Addendum No. 01

Subject: **Potter Thomas Classroom Modernization Project
B-021C, B-022C, B-023C of 2018/19**

Location: **Potter Thomas Elementary School
3001N. 6th Street
Philadelphia, PA 19133**

This Addendum, ***dated February 26, 2019***, shall modify and become part of the Contract Documents for the work of this project. Any items not mentioned herein, or affected by, shall be performed strictly in accordance with the original documents.

DRAWING TITLE
INTERIOR ELEVATIONS

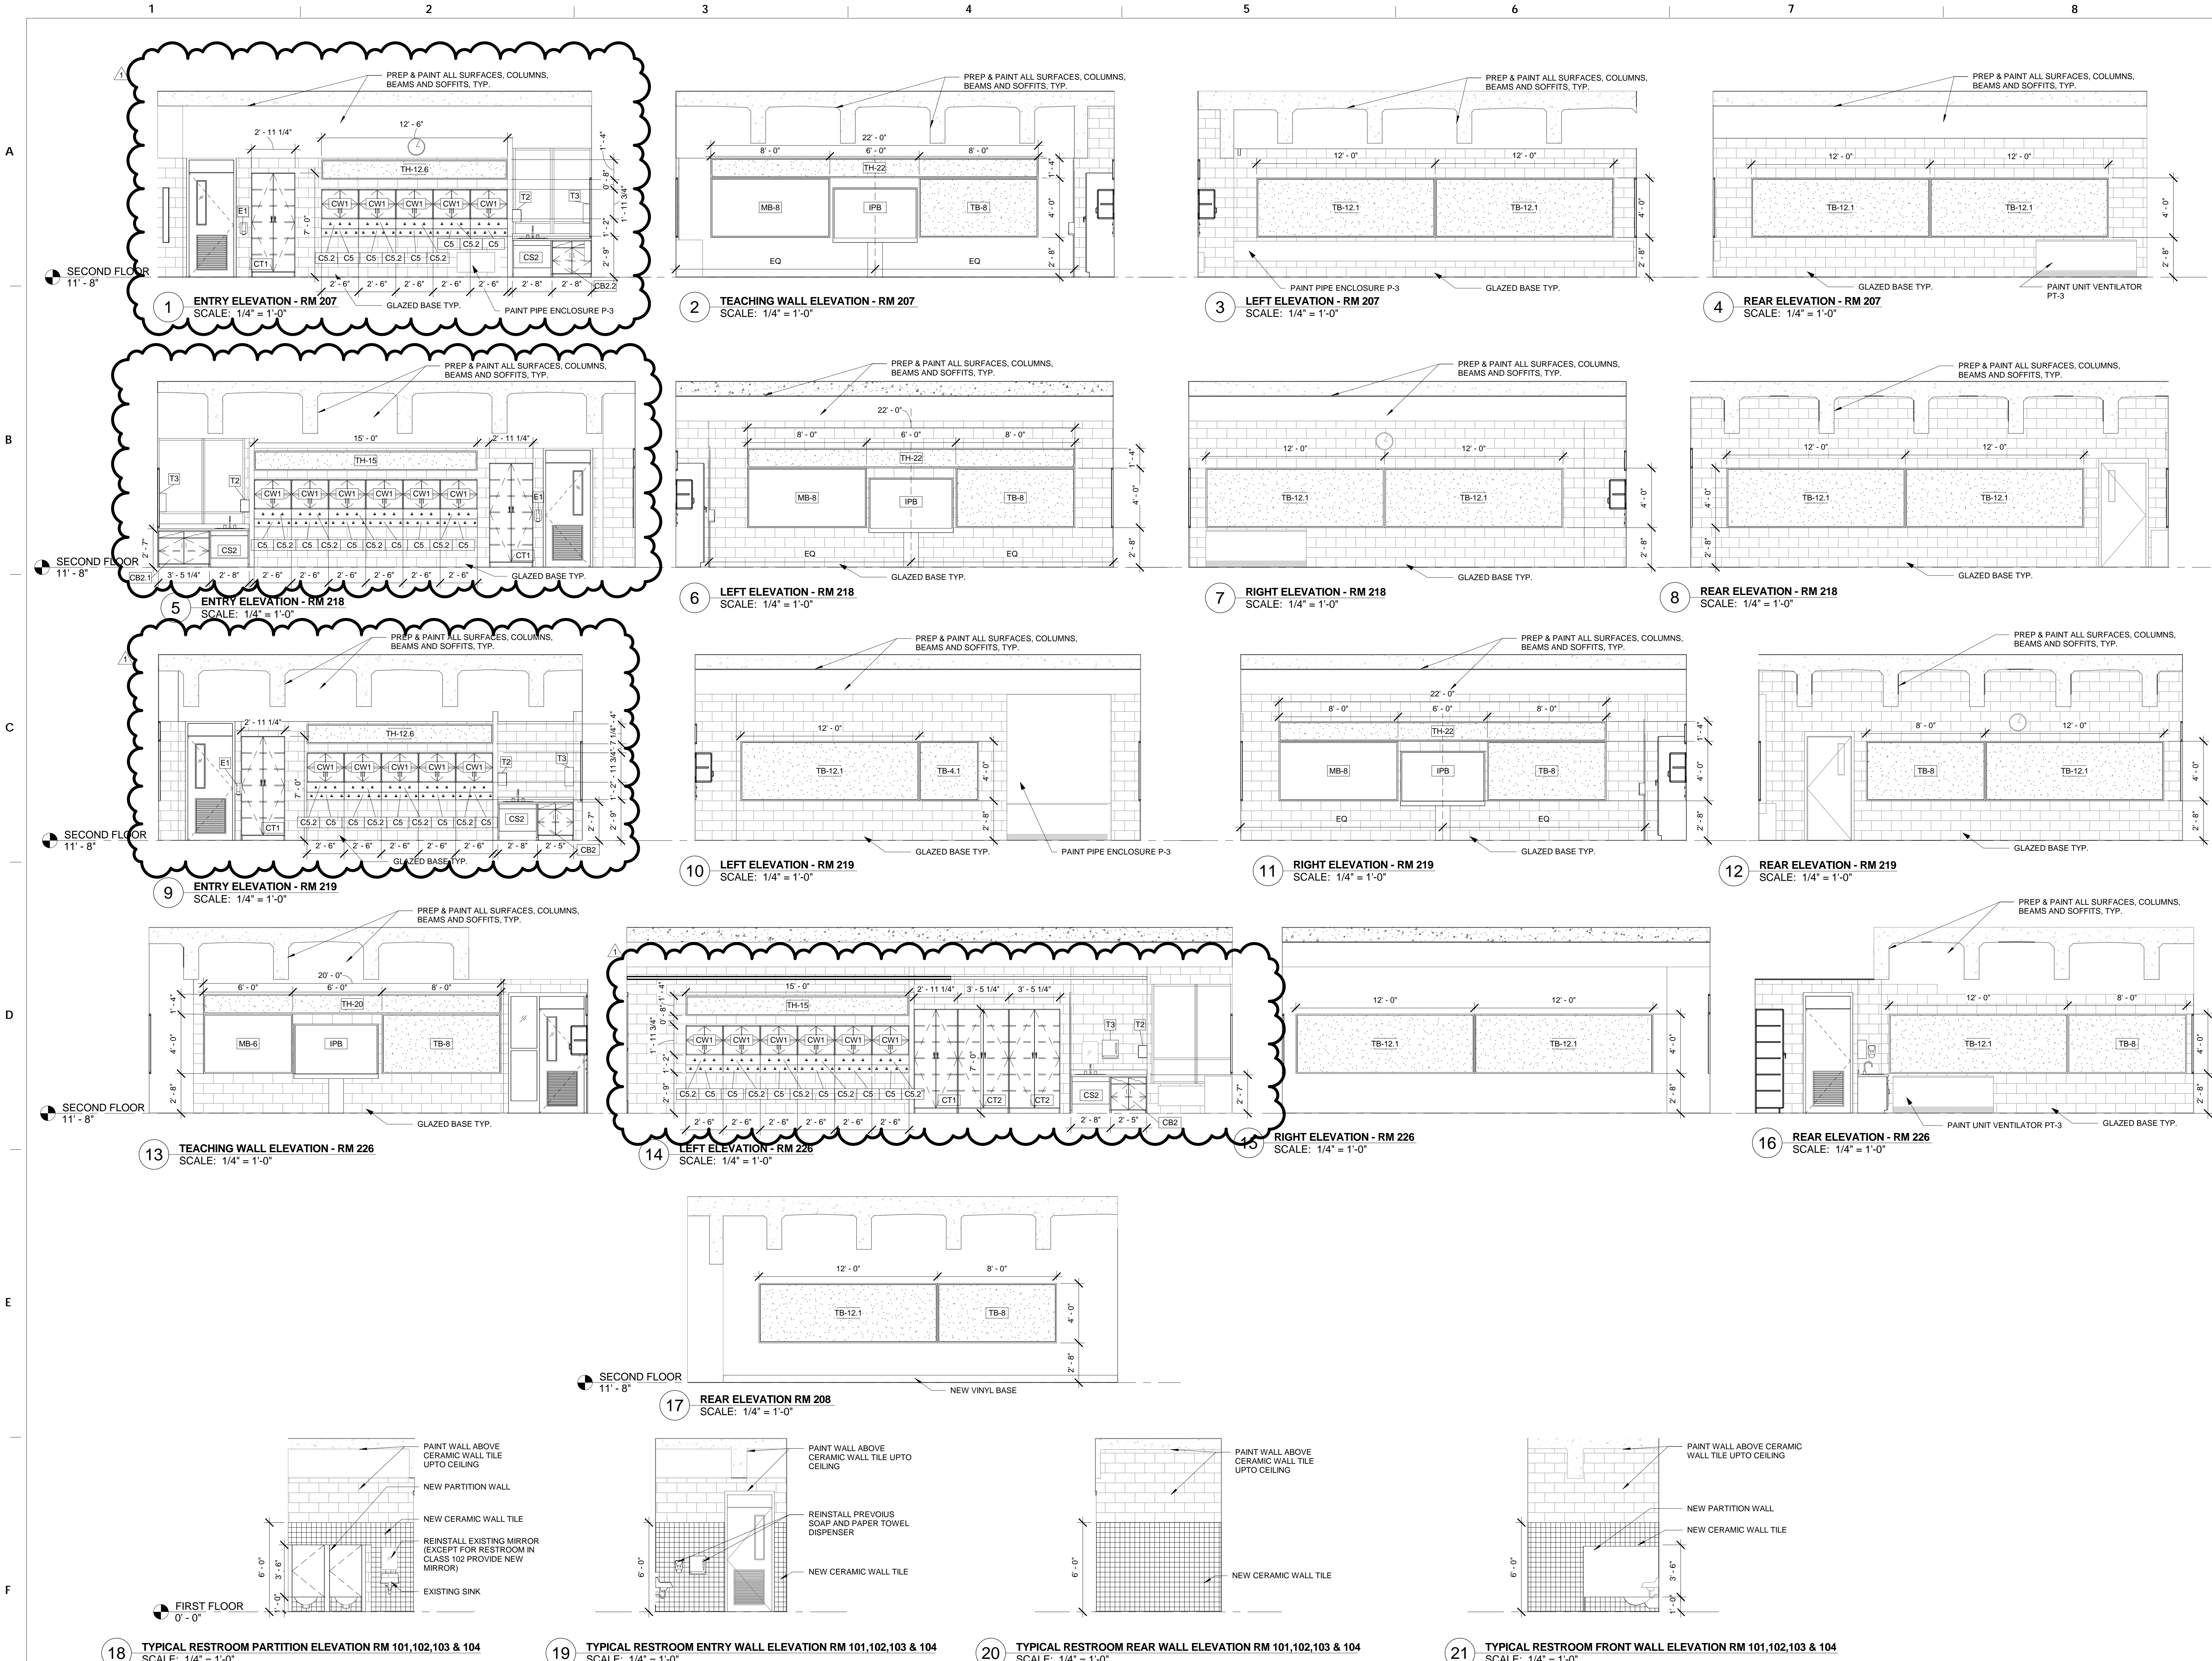
g. A303: INTERIOR ELEVATIONS

DETAILS 1, 5, 9, 14 ARE REVISED, SEE A303 REV 1 ISSUED WITH THIS ADDENDUM.
